# intel® Technical Advisory

TA-720-1

September 20, 2004

## Inadvertently grounding capacitor C305 on backside of board may cause CMOS corruption on Intel® Server Board SE7320SP2 or Intel Server Board SE7525GP2

Figure 1 Location of C305

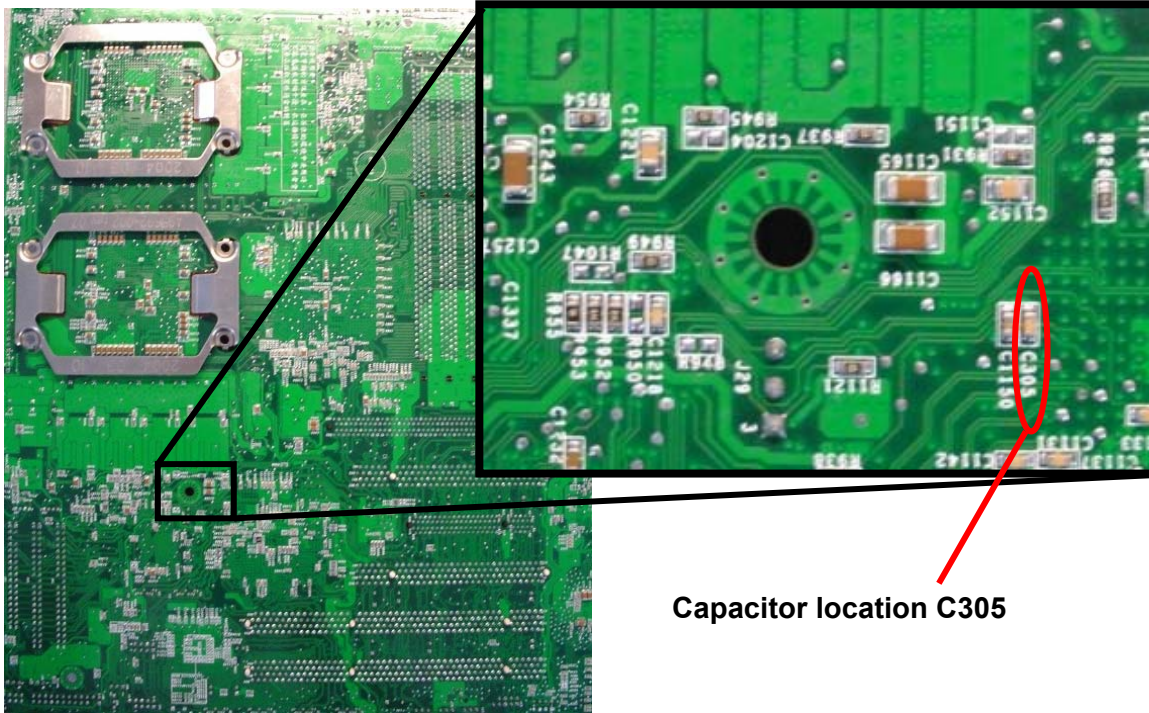
The capacitor at location C305 on the backside of the Intel Server board SE7320SP2 and SE7525GP2 (See Figure 1) has been linked to sightings of CMOS corruption at the Intel factory. This capacitor is a reference capacitor on the RTC\_RST circuit, sitting between this signal and ground. The RTC\_RST signal is an active low signal and is active even when the board is not plugged in since it's part of the CMOS circuit powered by the battery. If this capacitor is inadvertently grounded either by touching a metallic surface such as a chassis or is touched by a human hand, it can pull the signal low enough to cause corruption of the CMOS value.

Capacitor location C305

Intel is in the process of adding a step to the manufacturing line in which a Mylar\* cover is placed over the top of the capacitor, preventing it from coming in contact with any surfaces which may inadvertently cause this behavior. Boards with this Mylar cover will be available after 8<sup>th</sup> of October, 2004 (WW40). Intel will not be making any changes to the TA or PBA numbers on the board for this change.

As soon as possible, Intel will schedule a board change and will relocate this capacitor to the top side of the board where it will be less likely to come in contact with any surface which may accidentally cause this behavior.
